MILITARY SPECIFICATION

FILTER UNIT, NOTCH

This amendment forms a part of Military Specification MIL-F-28821(EC), dated 28 August 1975.

FIGURE 2. Notch filter channel isolation.

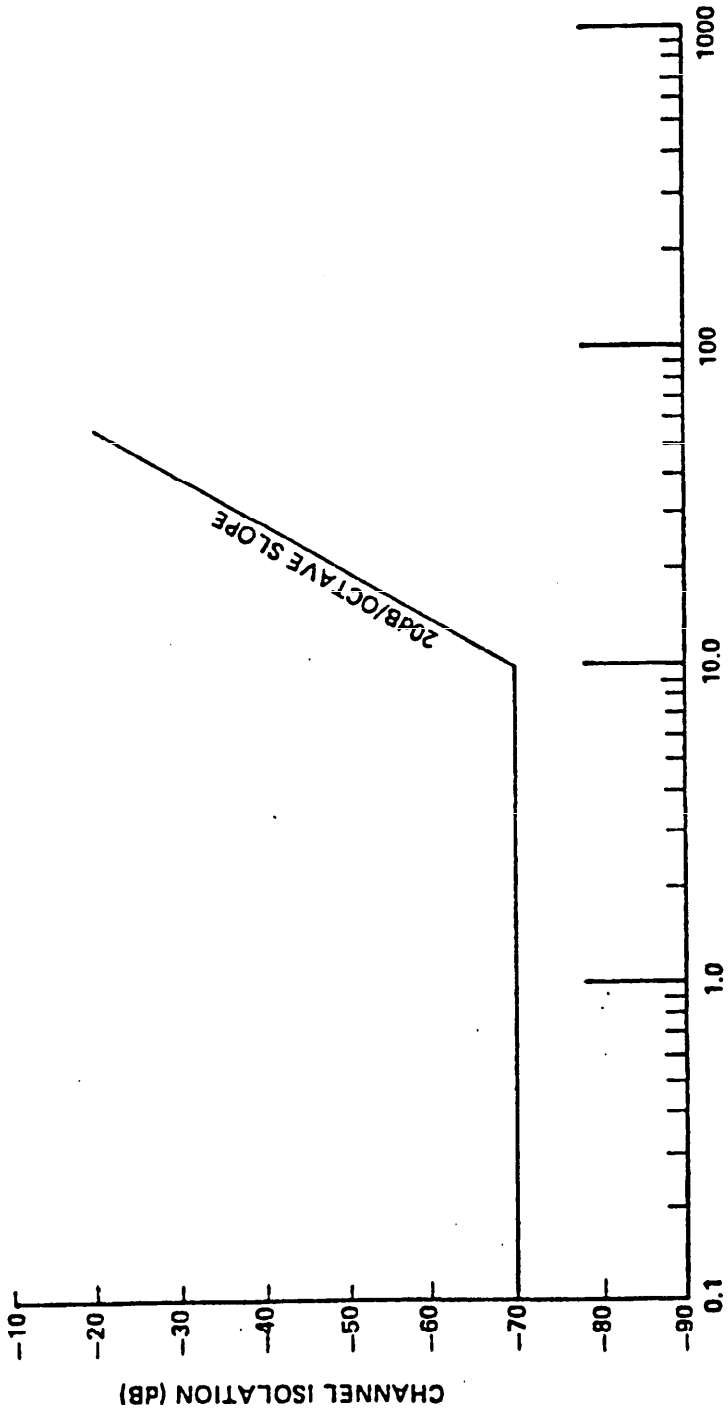
3.2.4, 3.2.5, and FIGURE 2: Delete and substitute:

3.2.8: Delete and substitute:

"3.2.8 Channel isolation. The isolation between the channels of a unit shall not be less than that indicated in FIGURE 2 with all filters switched in.".
